Burlington Design Advisory Board

DESIGN ADVISORY BOARD Tuesday June 8, 2021 3:00 PM REMOTE MEETING

MEMORANDUM

To: The Design Advisory Board
From: Mary O'Neil, AICP, Principal Planner
RE: ZP21- 450 OG 28 Sunset Cliff Road
Date: June 8, 2021

Drawing No.
C-3.0

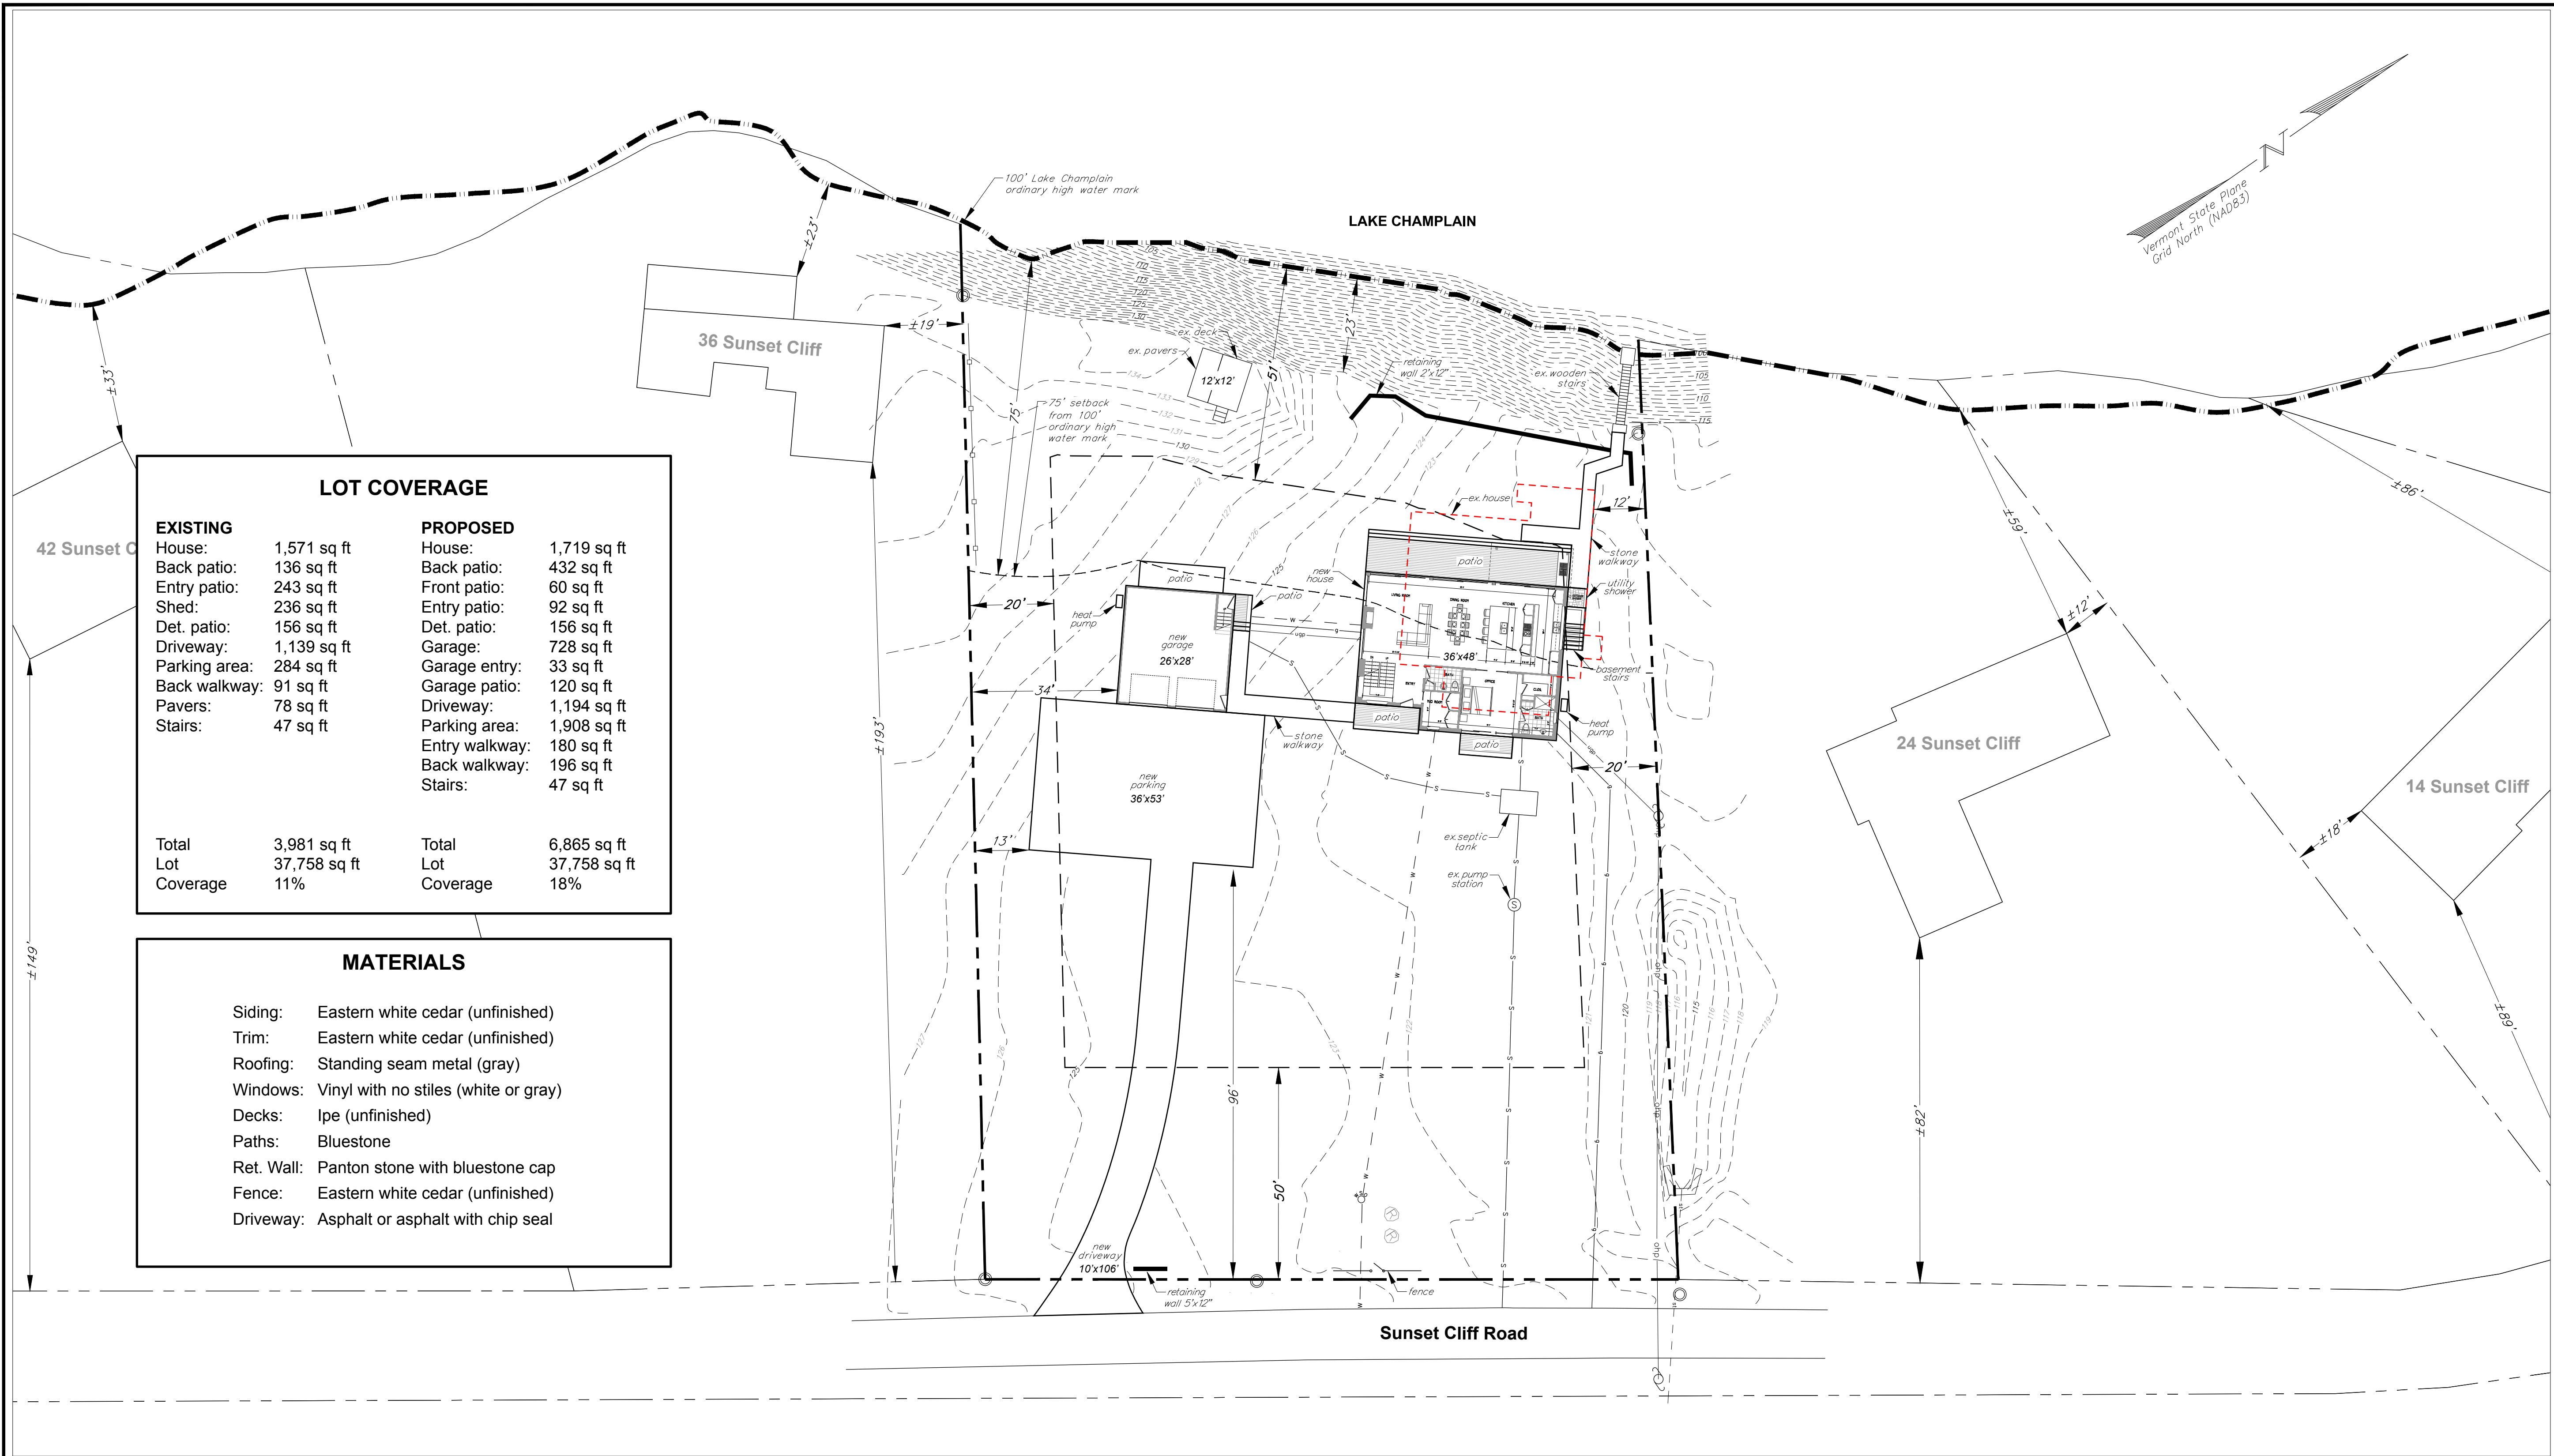
The site slopes gradually from east to west, toward the lake. Aside from construction disturbance, the existing topography appears to remain unchanged. A 2' x 12" retaining wall is proposed west of the new home. Plan C-3.0 defines the retaining wall as Panton stone with bluestone cap.

Waterfront setbacks can be based on the average of two adjacent parcels (not four), so the applicant will need to clean up the waterfront setback measurement, averaging only 36 and 24 Sunset Cliff Road. If existing setbacks on plan C-3.0 are accurate, the setback should therefore be 41' from the ordinary high water mark.

There is an existing, unpermitted structure within the waterfront setback (12'x 12') that will need to be removed from the plan as it encroaches within a required setback. Similarly, there is an unpermitted westerly porch that was not included in the 1994 site plan approval. If this encroaches into waterfront setback, it too shall be eliminated.

The driveway is proposed to be relocated south of its existing location. Plan C3.0 defines the driveway as asphalt or asphalt with chip seal.

A fence is described on Plan C-3.0, but identified on the site plan or landscaping plan. This shall be defined as to location and height.

2. Some manner of roof covering is recommended for both building entrances of the garage/ADU.
3. The applicant shall correct setback measurements on the plans, reflected an average of two adjacent properties along the shoreline, not four.

Drawing No.
C-4.0

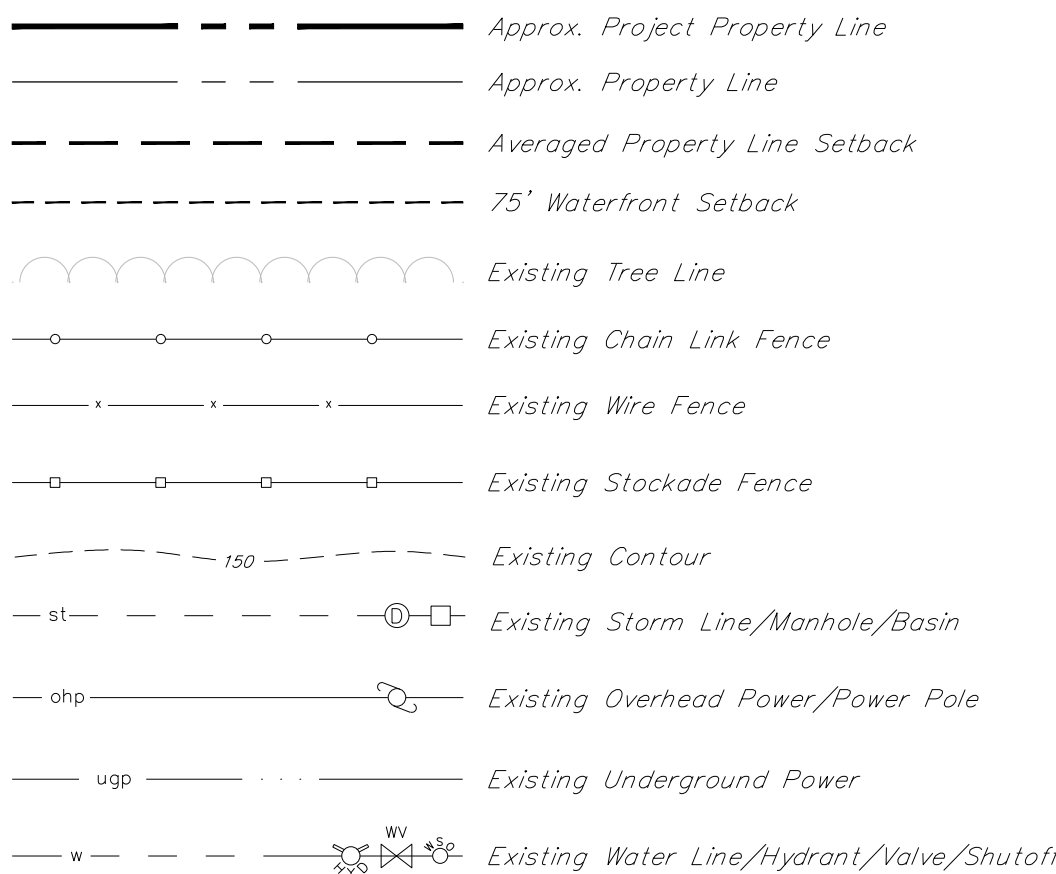
Any tree cutting along the waterfront requires review by the Conservation Board per Section 4.5.4. (c). The submitted landscaping plan (C-4.0) shows a plan focused on the northerly boundary, and around the perimeter of the lot. Mixed evergreen and native shrubs with native ground cover are the choices, with an allee of Maples along the driveway. The Clear Site Triangle must all be observed at the driveway entrance to provide safe sight distances for both pedestrians and vehicles.
